GUARDRAIL RELATED
MULTIPLE
OFFSET BLOCKS
FOR MGS AND MTBBC
SERIES DEVICES

805-545-00

SHAPE TRANSITION
THRIE-BEAM TO
SINGLE SLOPE

805-825-00

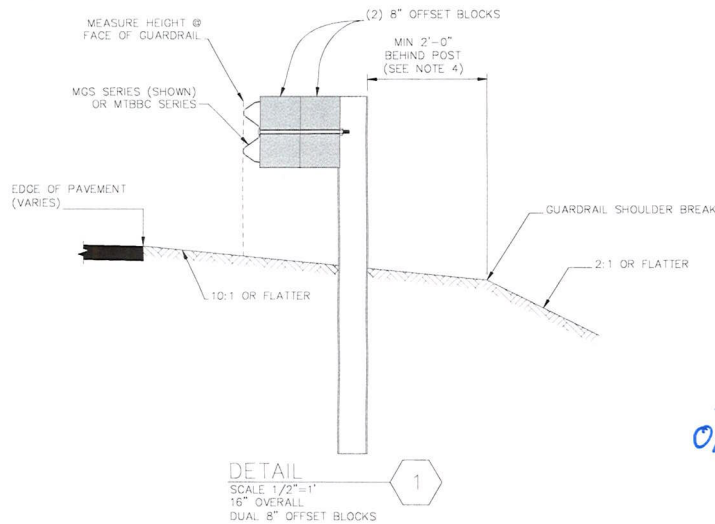
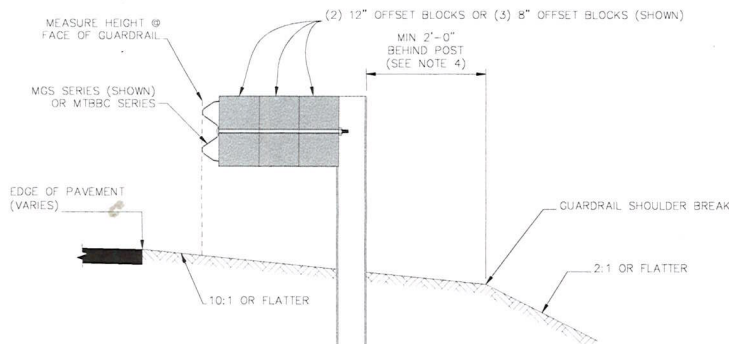
TRIPLE BLOCKS
MAY BE USED
ONCE EVERY
50-FT

~~RECOMMEND~~
RECOMMEND CHANGING
"WILL BE" TO "MAY BE".
AS THE POST MAY BE A
BIT TALLER IN GROUND
DEPENDING ON SLOPE
OF GRADING. - IF FLAT
THE POST REMAINS THE SAME.

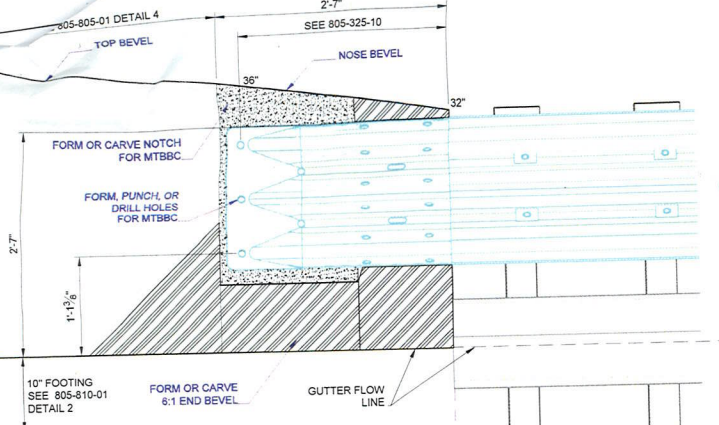
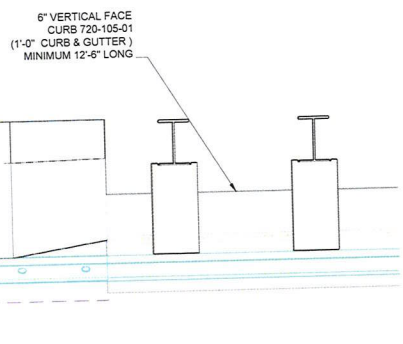
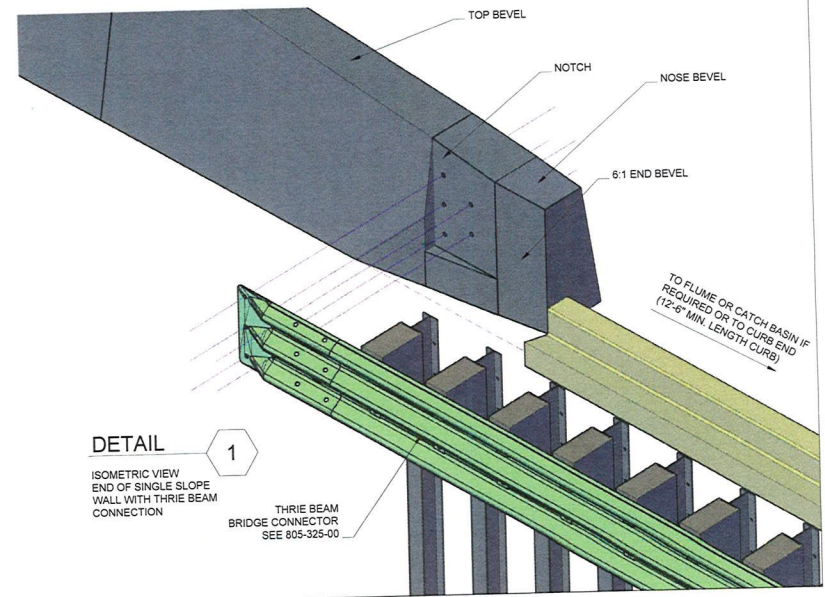
SEE STANDARDIZED
Buttress DETAILS & JOURNAL
PAPER.

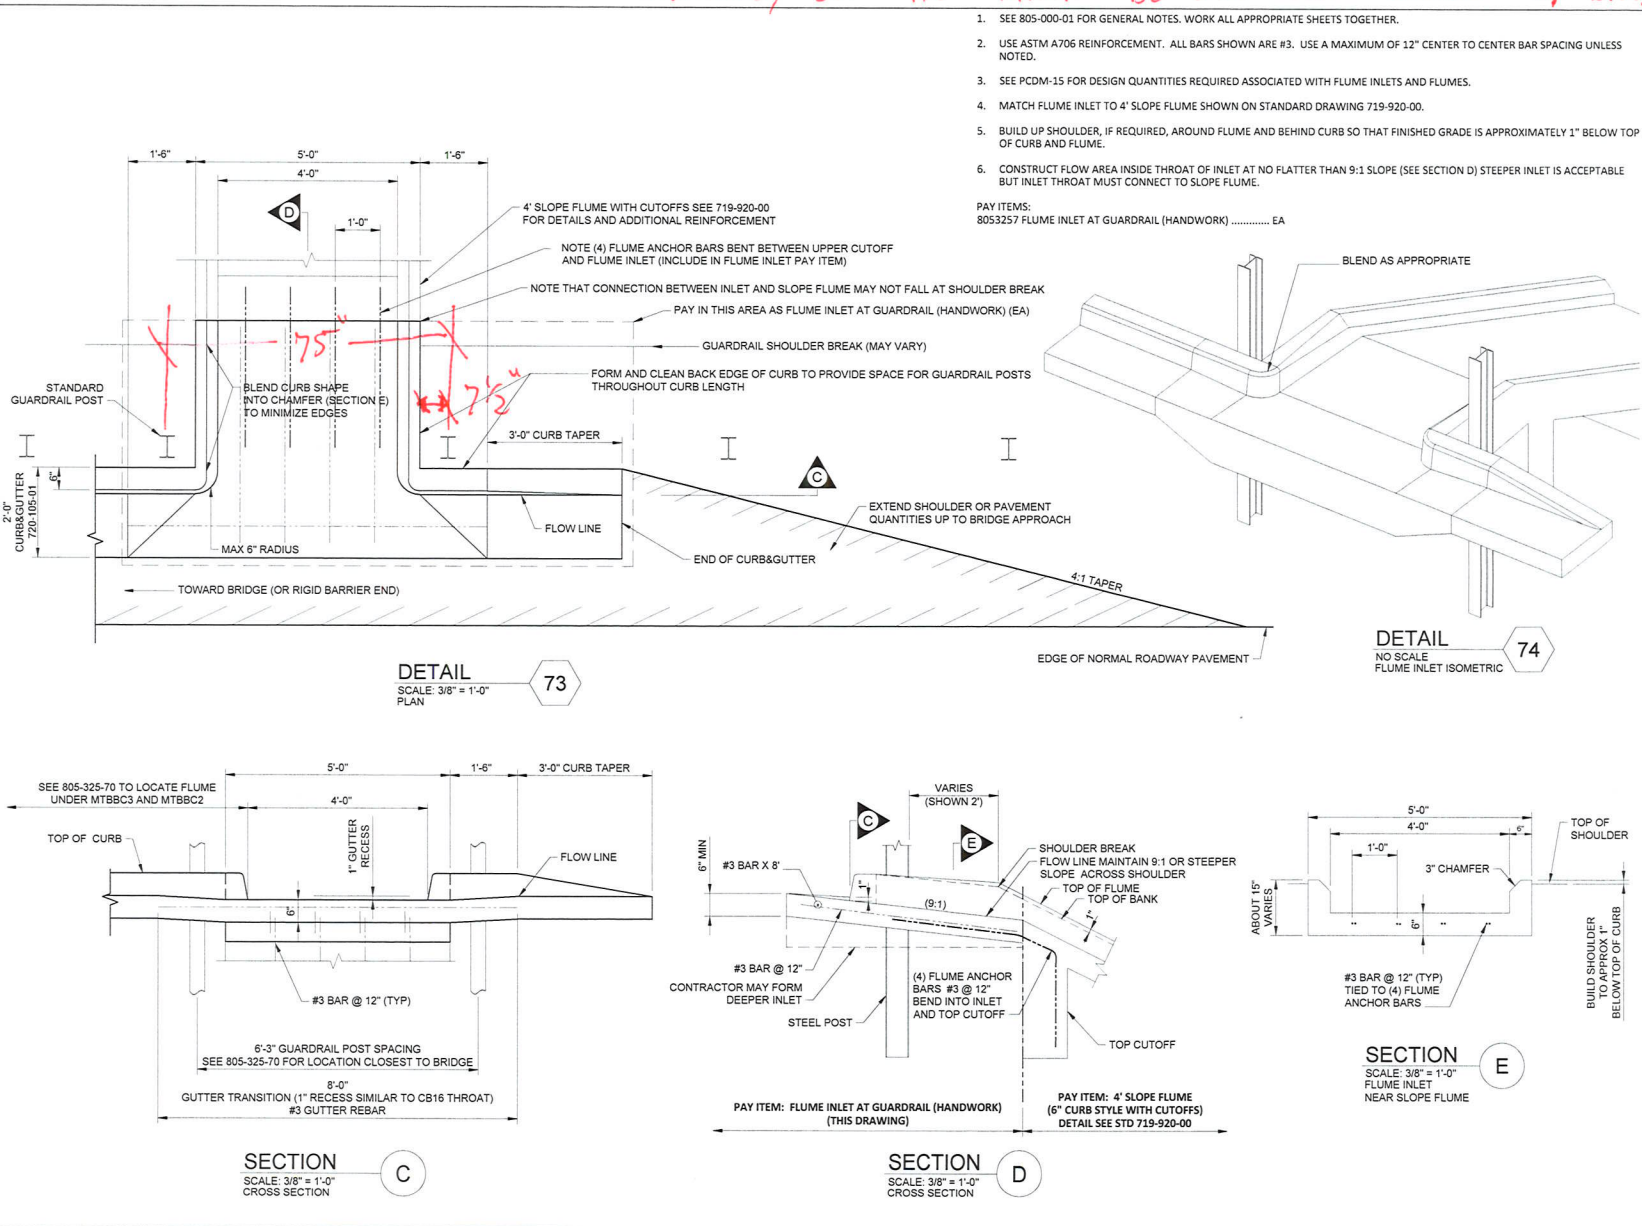
75" - 60" = 15"
 15" / 2 = 7.5"
 7.5" FROM CENTER OF POST TO EDGE OF FLUME

★ ADD NOTE THAT FLUME NEEDS TO BE CENTERED BETWEEN MGS POSTS.
 - 7.5" FROM POST TO CONCRETE FLUME IS A LITTLE TIGHTER THAN THE 9" DISTANCE USED FOR GUARDRAIL LEAVE-OUTS. THIS DISTANCE HASN'T BEEN EVALUATED. THE POSTS NEARLY TOUCHED EDGE OF LEAVE-OUTS DURING TESTING. THUS, I WOULD FEEL BETTER ABOUT A 9" DISTANCE, BUT 7.5" MIGHT BE OK. POST CONTACT W/ RIGID STRUCTURE PREVENTS POST DETENTION AND NEGATIVELY AFFECTS PERFORMANCE.

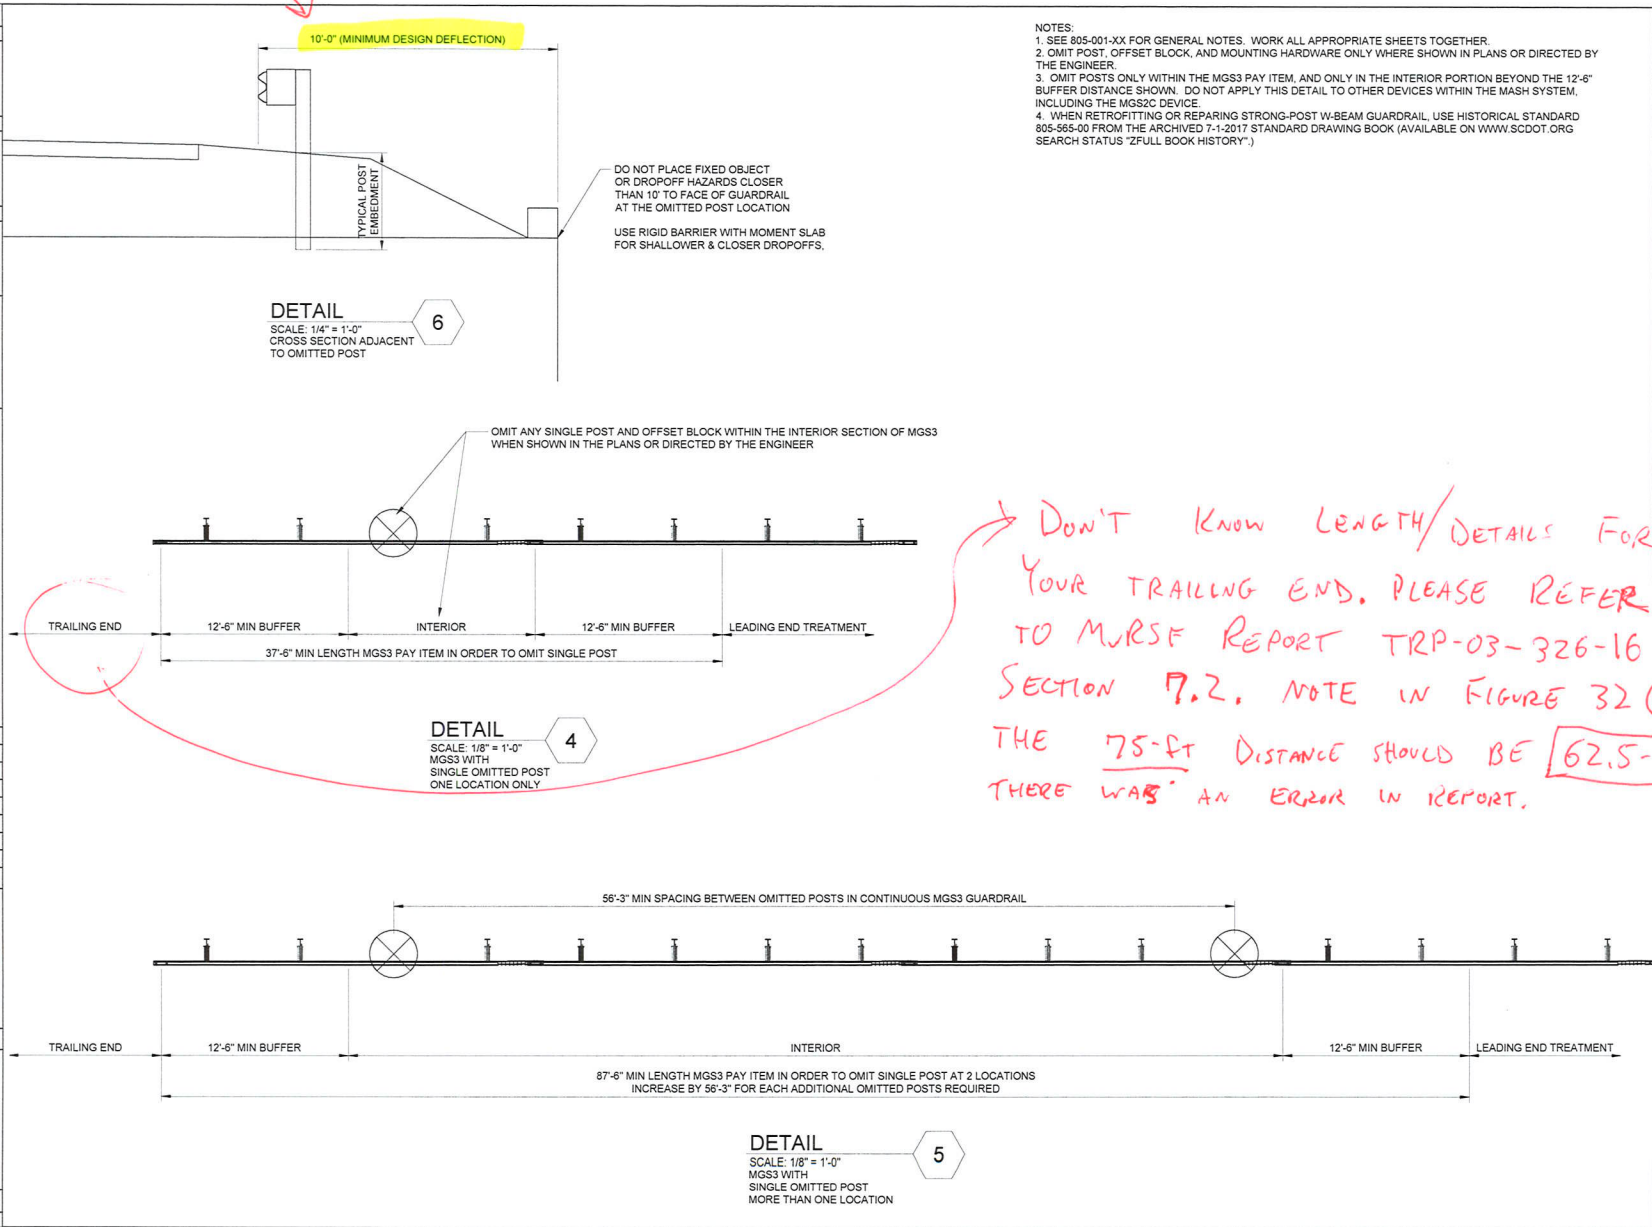
WORKING WIDTH FOR MGS OMITTED POST WAS ONLY 50.1 INCHES. SEE REPORT TRP-03-326-16, PAGE 38.

Don't know length/details for your trailing end. Please refer to MURSE REPORT TRP-03-326-16 SECTION 7.2. NOTE IN FIGURE 32 (C) THE 75-ft DISTANCE SHOULD BE 62.5-ft THERE WAS AN ERROR IN REPORT.
